**SUBJECT: Addendum No. 1**

**REFERENCE: Invitation To Bid (ITB) for William P. Hobby Airport Central Concourse Flooring Replacement Phase II; Solicitation No. HHG-HOUCCF-2023-010; Project No. 957.**

**ADDENDUM NO. 1 (Revised Drawings)**

**HOU CENTRAL CONCOURSE FLOORING REPLACEMENT – PHASE II**  
**HOBBY P. WILLIAM AIRPORT**

SHEET NAME: OVERALL FINISH FLOOR PLAN  
 SHEET No. A2-01 C      SCALE:

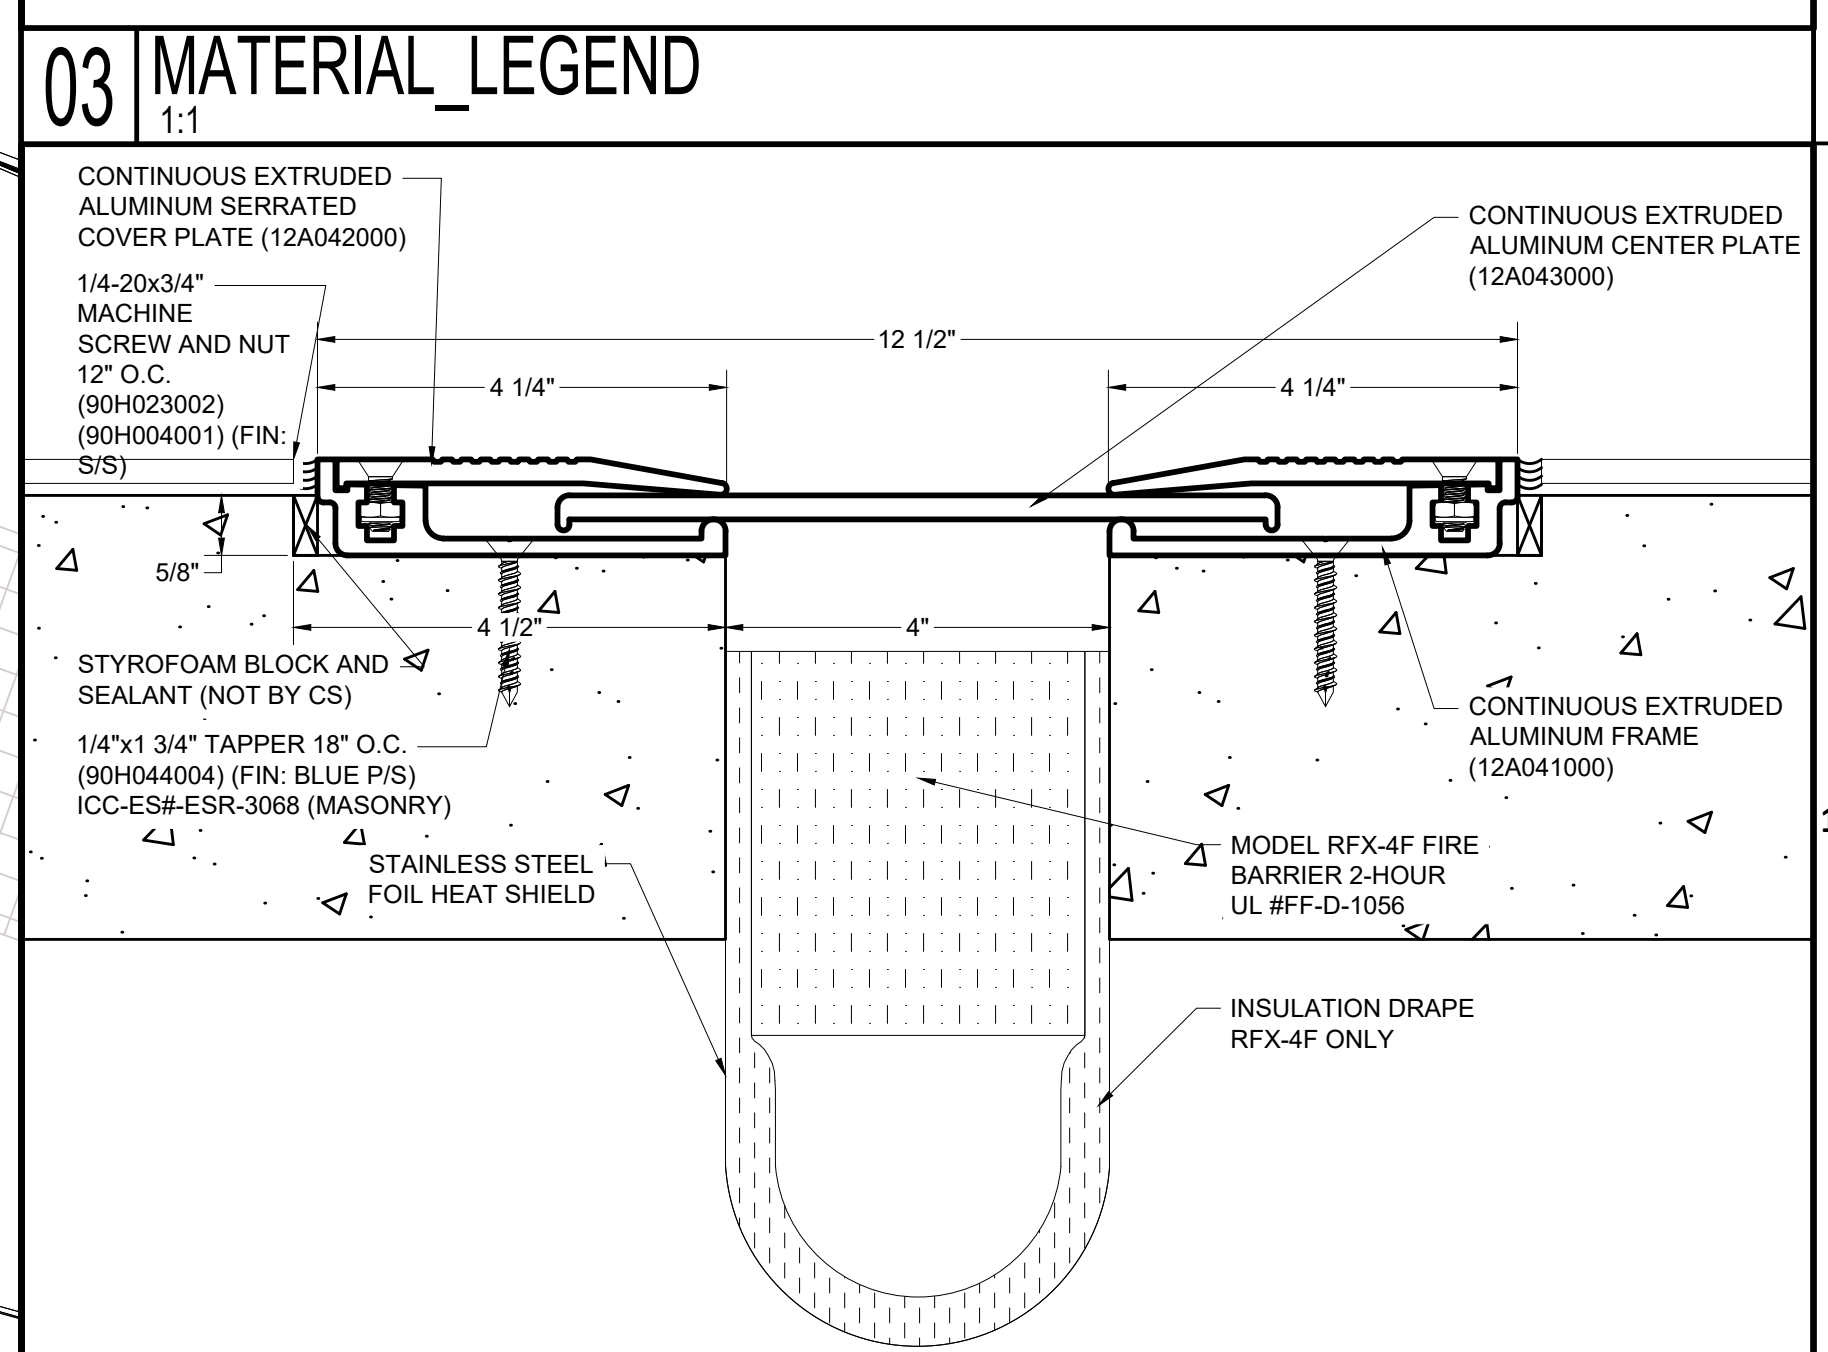
21. **Question:** Are the square footages on page A2-01C for the different areas indicate an estimate of the amount of square footage needing to be replaced?

- 3.1 Sheet G100 - Cover Sheet:
  - A. Modified date to include Addendum No. 1 date.
- 3.2 Sheet G110 - Index Sheet:
  - A. Modified dates on Index to include Addendum 01.
- 3.3 Sheet A1-01 - Overall South Concourse Plan:
  - A. Modified Detail 06.
- 3.4 Sheet A2-01C - Overall Finish Floor Plan:
  - A. Modified transition detail at end of people mover. See Detail 05/A1-01. Added note at Information Booth.
- 3.5 Sheet A3-01 - Enlarged Floor Plan Areas B& C:
  - A. Modified floor transition strip to restroom entrances. Added note for stainless steel base scope.
- 3.6 Sheet A3-03 - Enlarged Floor Plan Area A:
  - A. Modified floor transition strip to restroom entrances. Added note for stainless steel base scope.
- 3.7 Sheet A4-04 and A4-05 - Dimensional Control Plans D&E:
  - A. Modified existing column wrap locations.

**Response:** Yes, the square footage shown is the approximate area of installed tile. Additional tile will be necessary to accomplish this amount of finish flooring. Contractor to determine quantity of tiles required to provide cut tile pattern, waste material, and attic stock.
